Architect's Field Report

23 January 2022

15094 Community Bank Headquarters / Report Number 033

## #275: Missing corner grid

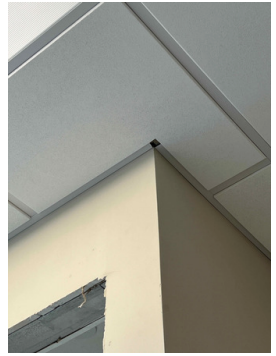
Description: **Missing corner at grid**

## #274: Inconsistent gap

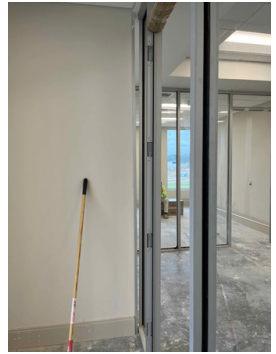
Description: **Gap between storefront and wall is crooked and needs to be straightened**

### #257: Missing fire proofing at steel beam

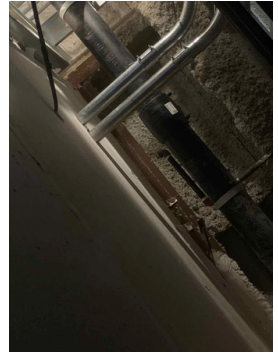
Assignee: **Stan Green (Fountain Construction Co., Inc.)** Description: **Inside wall cavity behind fountain near toilet rooms**

### #256: Improper fastener at tile backer

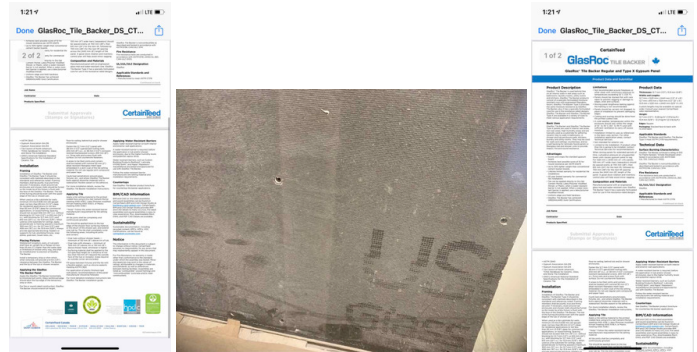
Assignee: **Ben Adams (Acoustics, Inc.)** Description: **Replace tile backer fasteners with corrosion resistant screws per manufacturer's documents.**

**#226: Lower portals for ceiling at hvac**

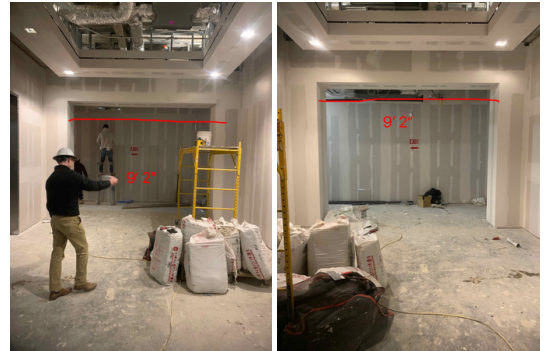
**Lowered bulk heads and  
ceiling. The 2 portals at  
Elevator Lobby 2001 need to be  
lowered to 9'-2" to  
accommodate HVAC  
installation at Hall 2003 which  
prevents the ceiling in this hall  
from being 10'-1". This ceiling,  
at hall 2003, should be lowered  
to 9'-3".**

**#217: Returns to wall missing correct substrate**

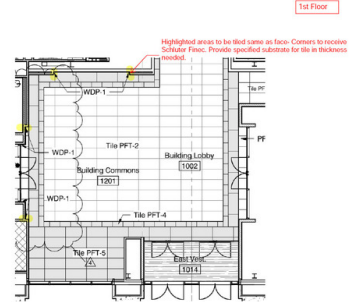
Assignee:  
**Ben Adams (Acoustics, Inc.)** Description:  
**Return walls need tile substrate**

**#215: Replace Substrate for Tile Finish Surface**

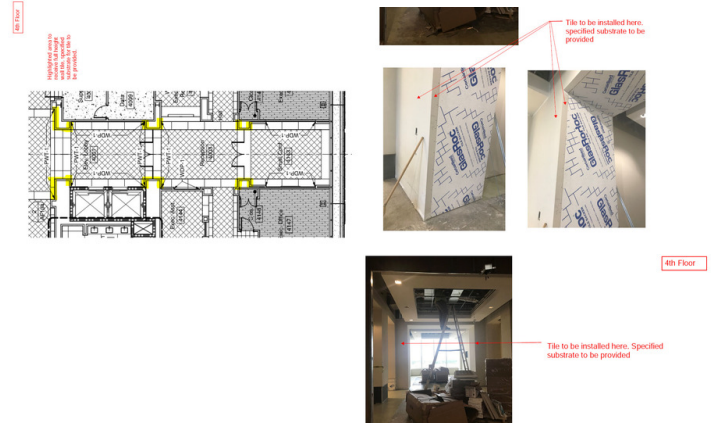
Description:  
**Substrate for tile is missing; drywall has been finished in it's placed. Replace substrate for new tile finish per A-483**

**#212: Balcony Curtain Wall with Protruding Ledge**

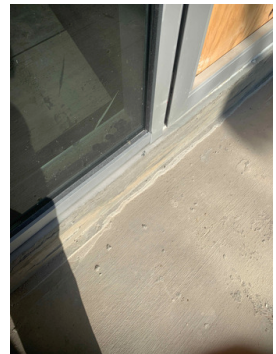
Description:  
**Per the latest detail concerning balcony flashing, this ledge Poses an issue and will need to be corrected:**

**This condition and any like it will need a flashing over the top of the concrete and below the curtain wall to prevent moisture infiltration into concrete. Contractor will need to dig out installed caulking and bed in a piece of flashing at least 1 inch beneath curtain wall; seal to curtain wall. This flashing shall overlap with drip edge the termination bar to be provided at TPO. This flashing shall match curtain wall finish and needs to be a MIN of 16 GA.**

### #211: Missing drip line

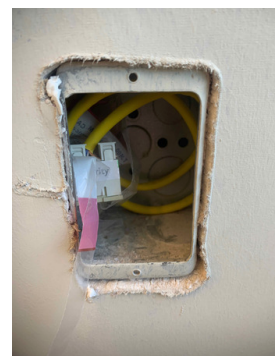
Type: **Work to Complete > Misc Issues**  
Location: **Interior>Level 4>4203 Private Dining**  
Trade: **Initiated**  
Status: **Initiated**  
Date Notified: **2021-12-20**  
Priority:  
Due Date: **2021-12-21**  
Spec Section:  
Assignee: **Robert Clay (Fountain Construction Co., Inc.)**  
Description: **There is no drip line here**  
Created By: **Paul Purser**
